Technical Service Bulletin (TSB)
RSU With Additional Sleep Cycles for HV Battery Integrity Check
- Flash: Battery Pack Control Module (BPCM) Updates 11B3

REFERENCE:	TSB: 08-076-25 REV. D GROUP: 08 - Electrical	Date:	December 18, 2025	REVISION:	08-076-25 REV. C
VEHICLES AFFECTED:	2024 (KM) Jeep Wagoneer S This bulletin applies to vehicles equipped with 400V G2500 FR/RR Elec Drive Motors (Sales Code ELD).			MARKET APPLICABILITY: <input checked="" type="checkbox"/> NA <input type="checkbox"/> MEA <input type="checkbox"/> SA <input type="checkbox"/> IAP <input type="checkbox"/> EE <input type="checkbox"/> CH NOTE: This bulletin applies to the North America market.	
CUSTOMER SYMPTOM:	<p>Customers may experience a Malfunction Indicator Lamp (MIL) illumination and the vehicle may exhibit/set one or more of the following Diagnostic Trouble Codes (DTCs):</p> <ul style="list-style-type: none"> ● **P1E25-00 - EV Battery Failure Level 2. ● P0D10-00 - Hybrid/EV Battery Negative Contactor A Stuck Open. ● P0D09-00 - Hybrid/EV Battery Positive Contactor A Stuck Open.** ● P0DE6 - Hybrid/EV Battery Pack Cell Voltage Low. <p>NOTE: Active or stored.</p> <ul style="list-style-type: none"> ● P1DAF - In

Fig. 1
Cooling Fan Assembly

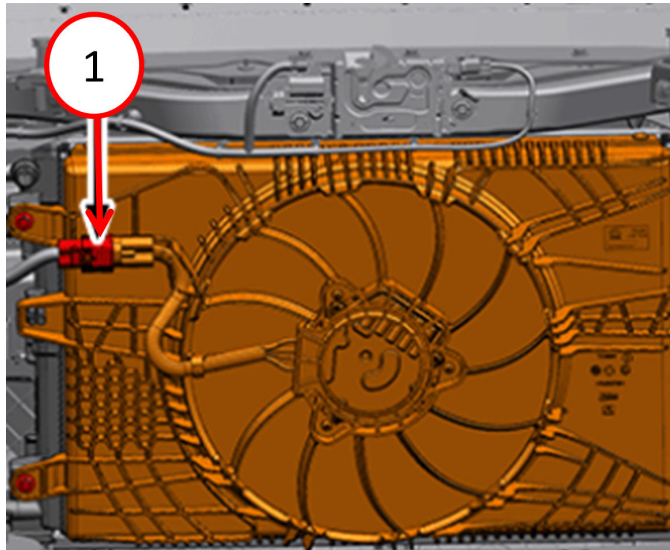
4. Disconnect the cooling fan wire harness connector [Fig. 1](#).

33. **Install the #32 AGSM/GSM fuse and the front PDC cover [Fig. 2](#)**.
34. Connect the cooling fan wire harness connector [Fig. 1](#).
